Appendix 3: Draft response to DfT on behalf of DDC as Local Planning Authority

The Department for Transport (DfT) is proposing to construct an Inland Border Facility (IBF) on a site at the White Cliffs Business Park to the north of Dover ("**the Site**"). The purpose of the IBF is to provide additional space for customs and transit checks for goods starting and ending the transit movement to and from the UK, in response to new rules on trade, travel and business between the UK and European Union that came into effect from 1 January 2021.

a) The development of an Inland Border Facility, comprising the change of use of land, erection of buildings, and associated landscaping and infrastructure works, on land to the east of Honeywood Parkway and south of the A2, White Cliffs Business Park, Dover.

Figure 5: Existing and Proposed Route of North Downs Way

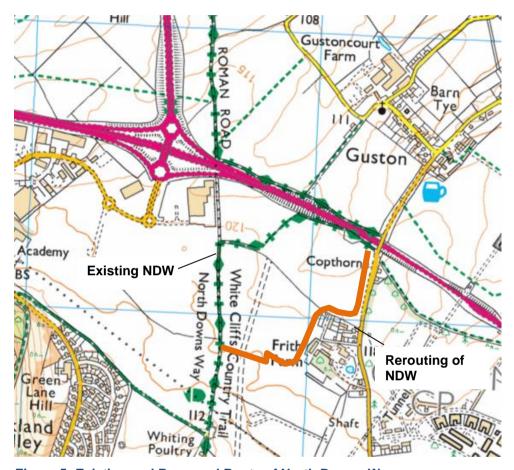
- 2.31 Whilst the proposed IBF would maintain the alignment of Roman Road with a buffer on either side, the NDW is proposed to be diverted. The diversion would start from where the NDW currently crosses the A2 on Dover Road, for it to pass through the landscaped area on the eastern side of the Site, then run beneath the southern access road (proposed Fastrack / BRT route), before re-joining its current alignment on Roman Road. This diversion is also shown at **Figure 5**.

2.32 It is recognised that some importance and historic significance of the NDW would be lost by diverting it from Roman Road, and that the alternative route would be set within a less mature landscaped setting alongside the IBF boundary fence and closer to nearby residential and farm buildings. However, given this would only be for a temporary period (as proposed until reinstatement works are completed by December 2026) and the NDW (as well as Byway ER60) is capable of being diverted back to Roman Road in due course, the proposed alternative route is considered an appropriate solution at this stage.

- 2.33 The Rights of Way Officer has confirmed in discussion that KCC is also agreeable to the temporary diversion of the NDW and Byway ER60 as proposed, subject to further details in respect of its surface treatment, width, screening from the development, and landscape treatment.
- 2.34 Officers are aware of work by the AONB Unit to seek an alternative and potentially permanent rerouting of the NDW, westwards from its current alignment to pass through
